**TOWN OF HERNDON, VIRGINIA
HERITAGE PRESERVATION REVIEW BOARD
WORK SESSION AGENDA
FEBRUARY 6, 2019
HERNDON COUNCIL CHAMBERS BUILDING
765 LYNN STREET
7:00 P.M.**

APPLICATION FOR A CERTIFICATE OF APPROPRIATENESS OF AN AMENDMENT TO AN APPROVED APPLICATION, HPRB #19-02.

An application to consider a Certificate of Appropriateness approving design revisions to the approved alterations, previously authorized through HPRB #17-15, to the commercial structure located at 765 / 767 Elden Street, Herndon (Attachment #1).

NORTH-WEST PERSPECTIVE

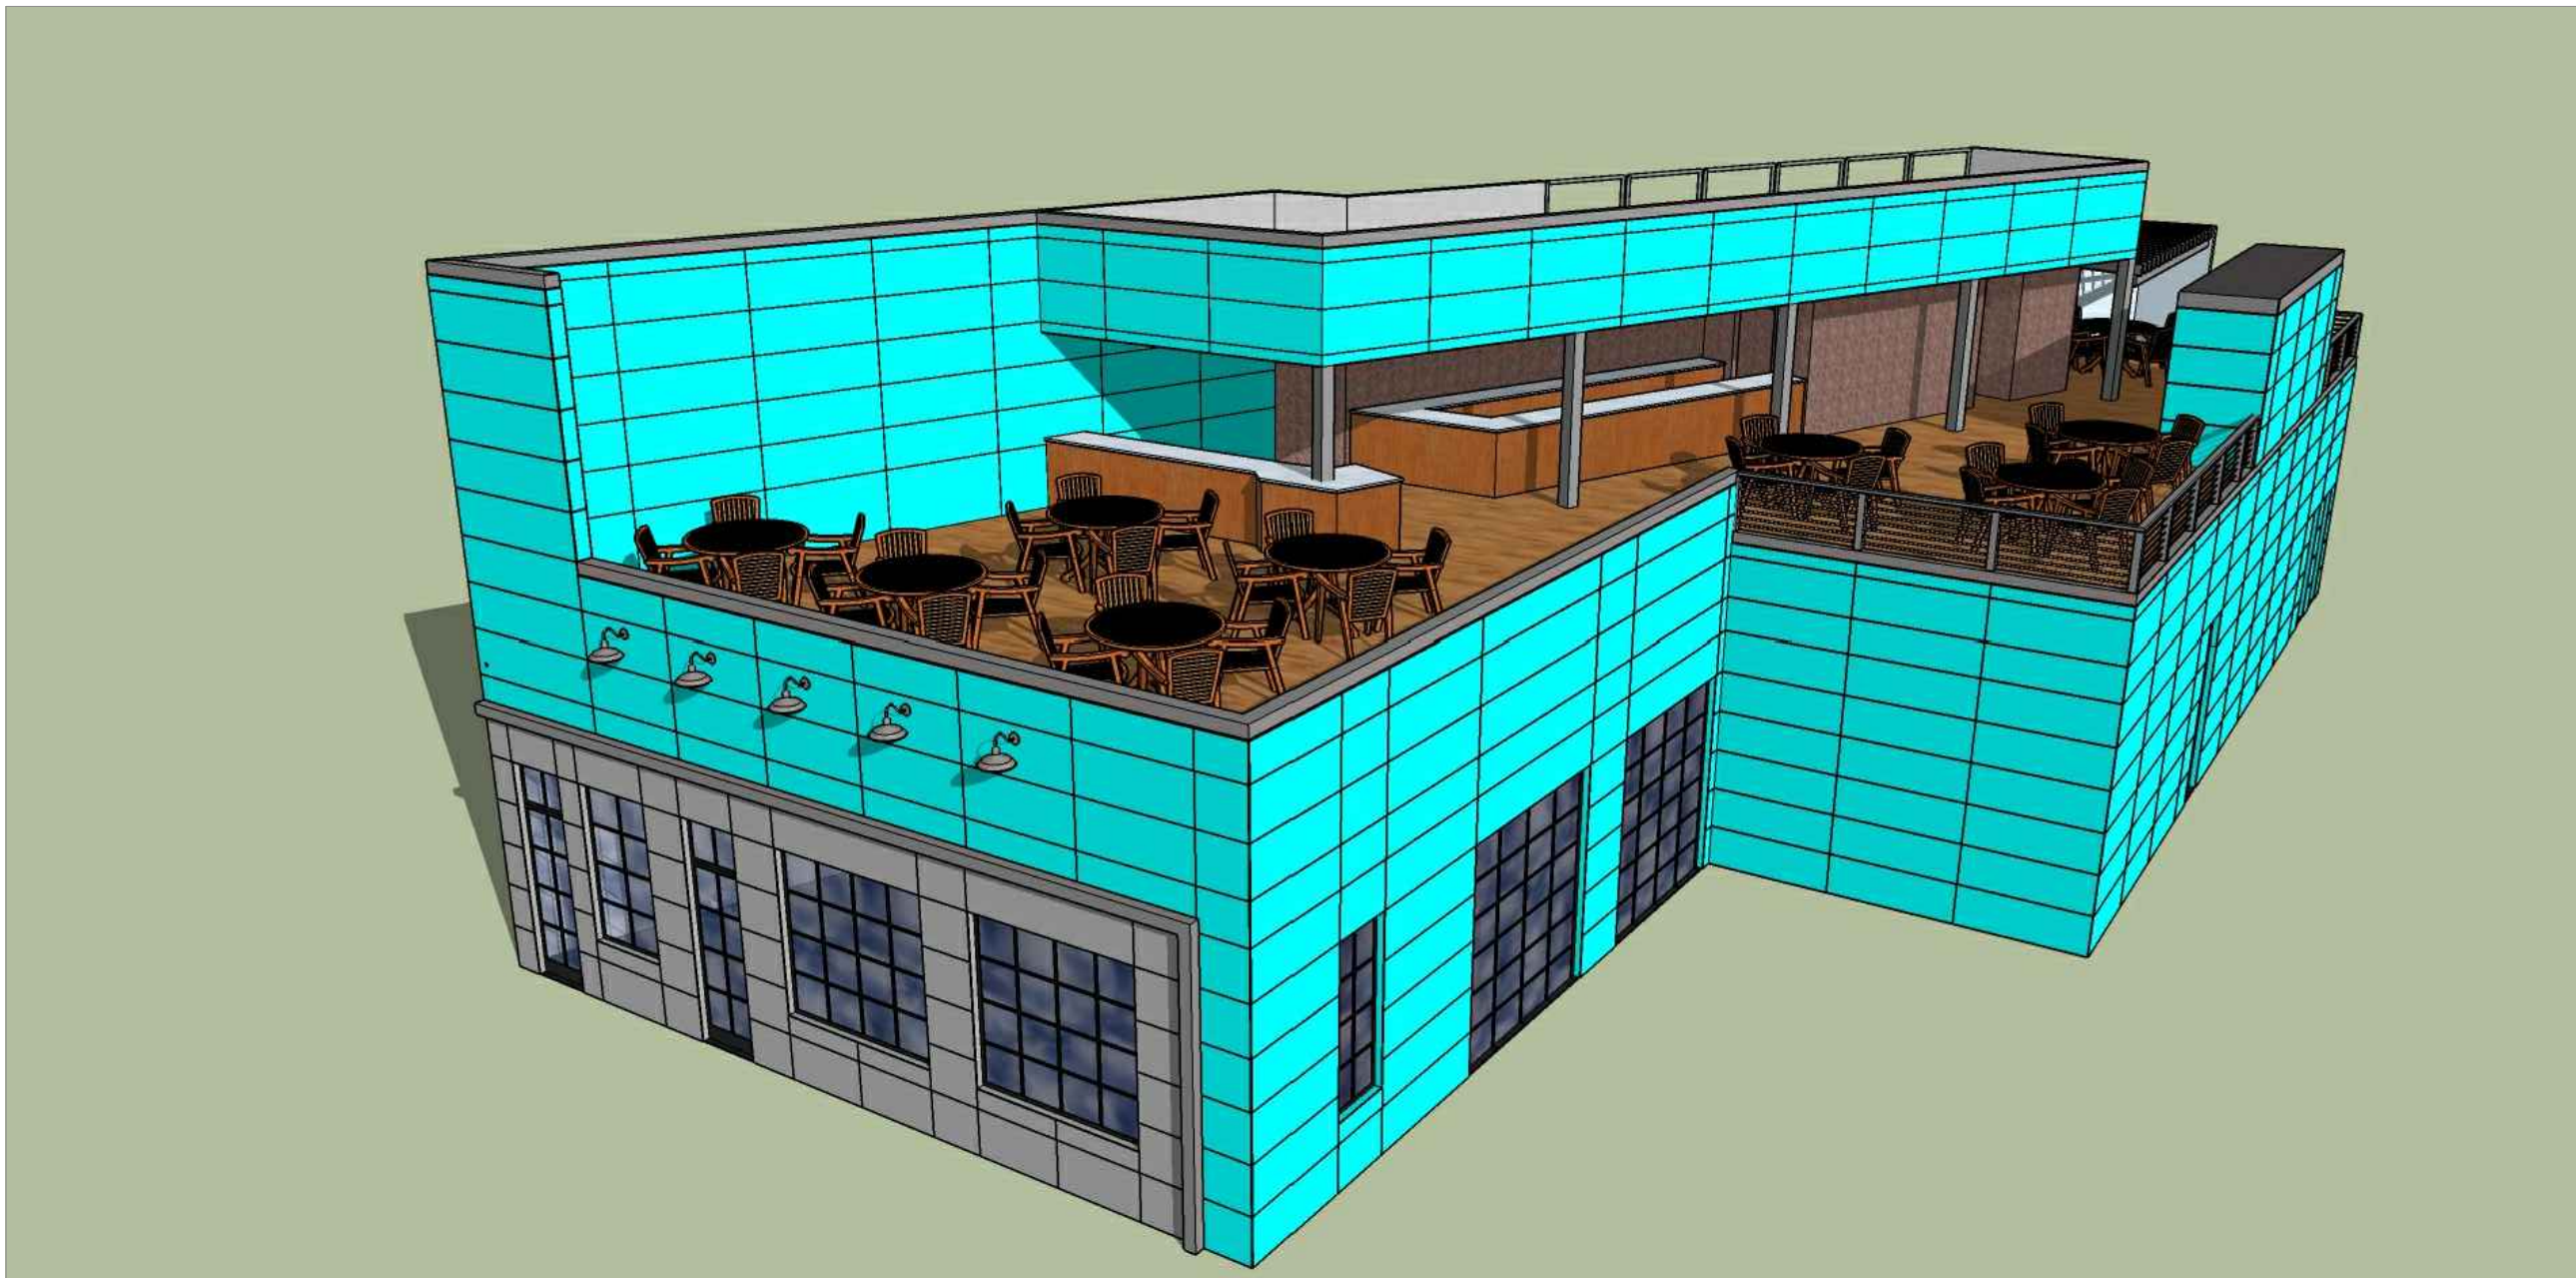
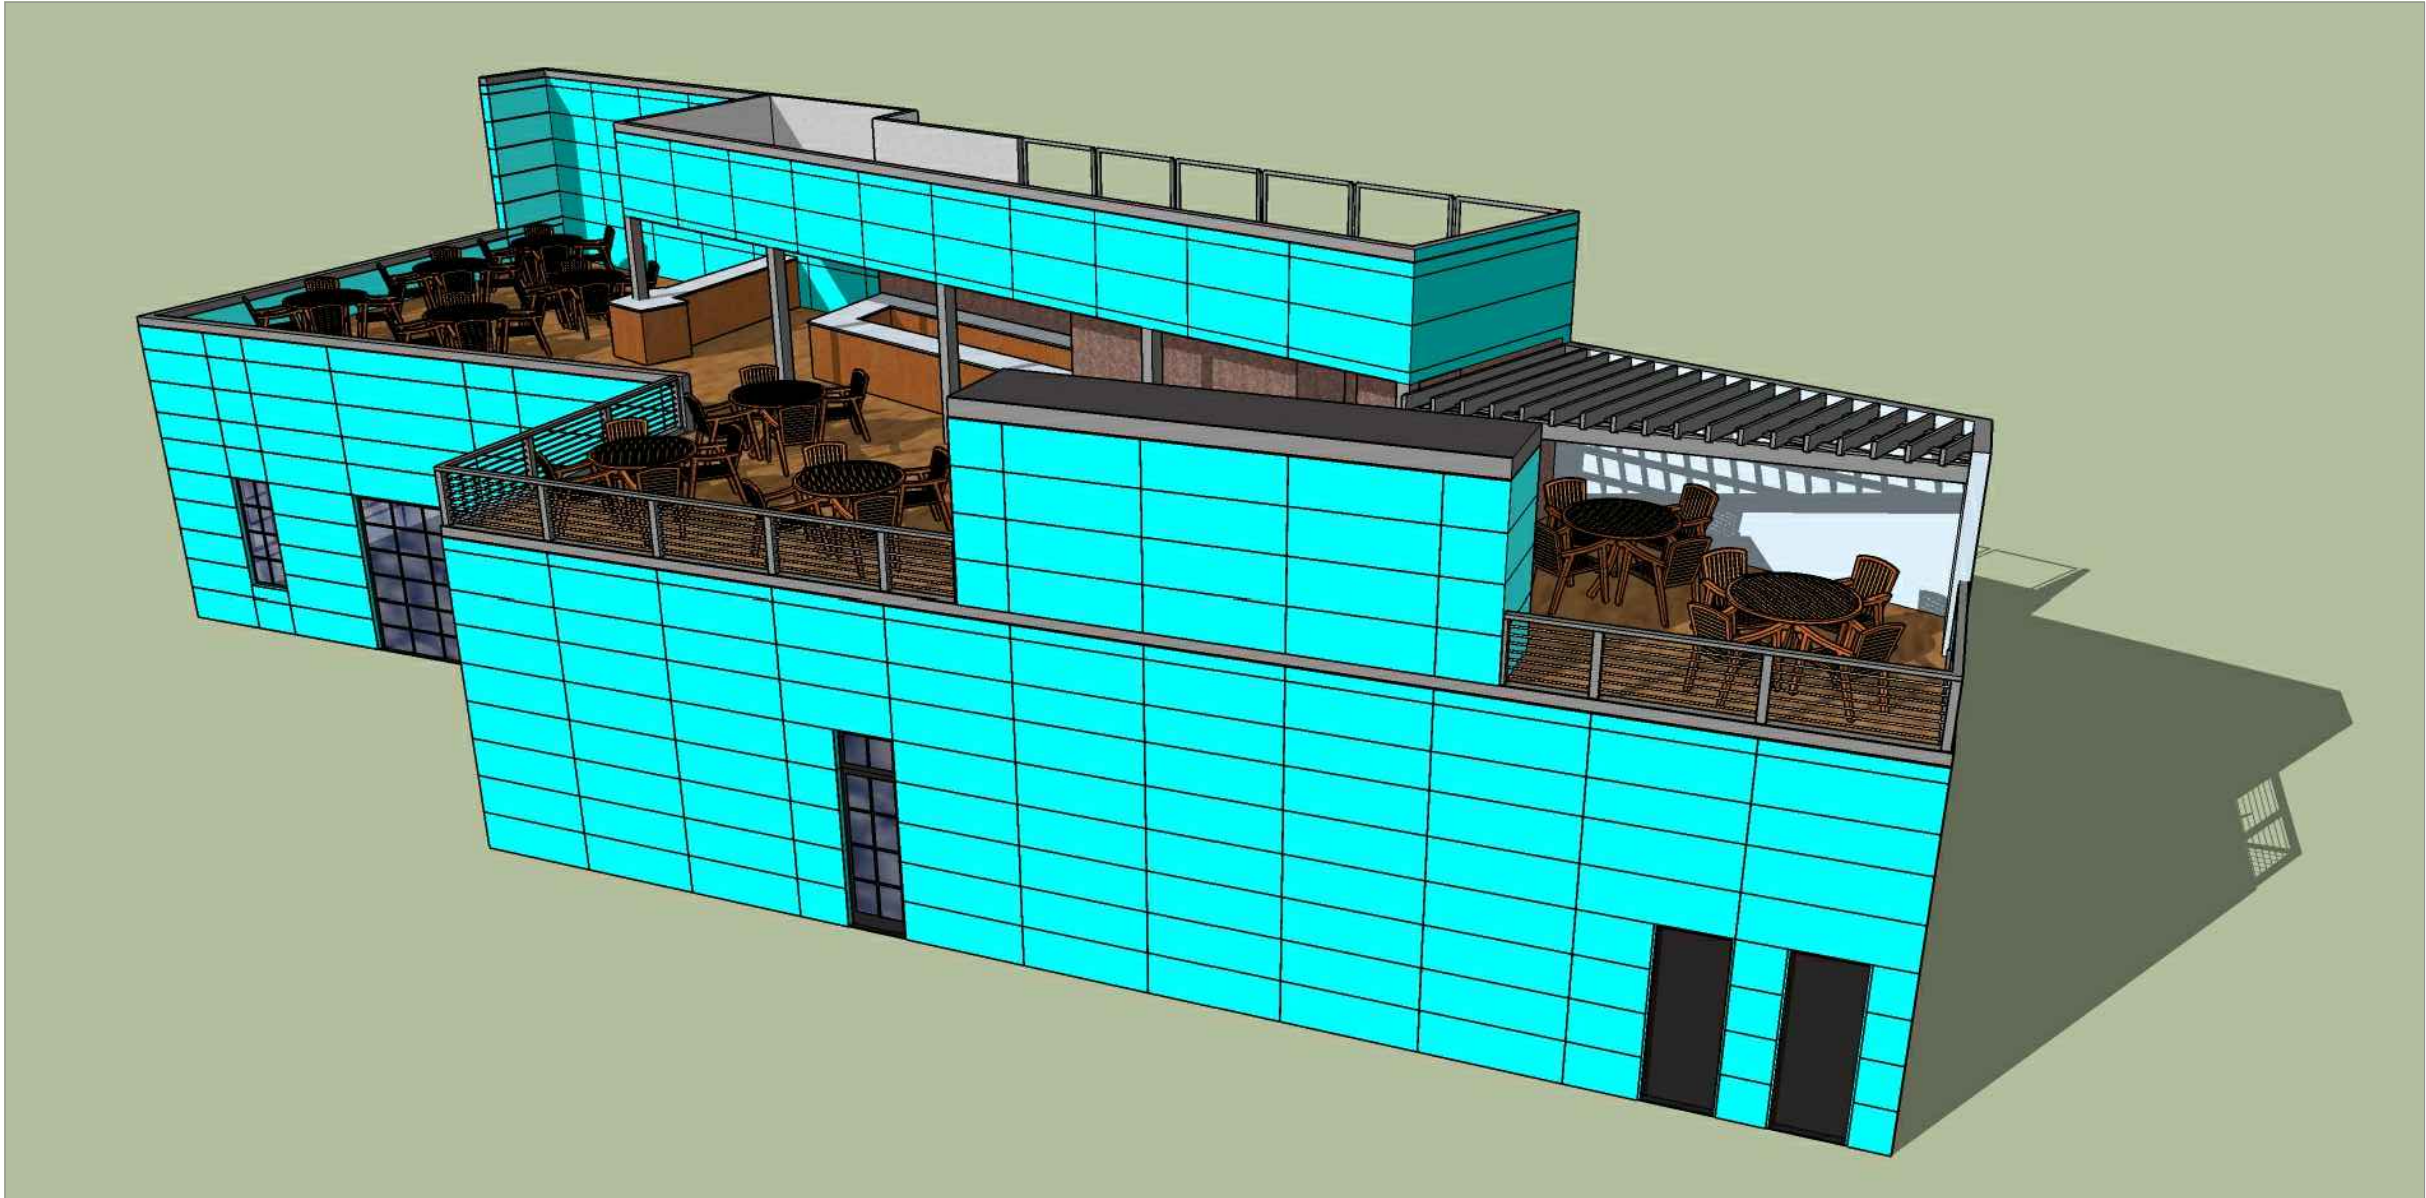
1. The applicant shall resolve the discrepancy of the Applicant Letter (Attachment #3) and the submitted building elevations with new drawings and/or formal description noting the following:
 - a. Identifying the second-floor walled enclosure with materials for the enclosure specified
 - b. Clarify the removal of the black wire mesh screen from the new elevation design(s)
 - c. Clarify the color variation of exterior building material between the original approval and the new design

- a. Identification and detailed information related to the new walled stairwell enclosure
 - b. Clarification and explanation of the removal of the black wire mesh from the second floor of the west and south elevations

- c. Clarification of the color variation between the original design and the revised design. The new design material color of the rain screens appears lighter in the revised elevations and perspective renditions.
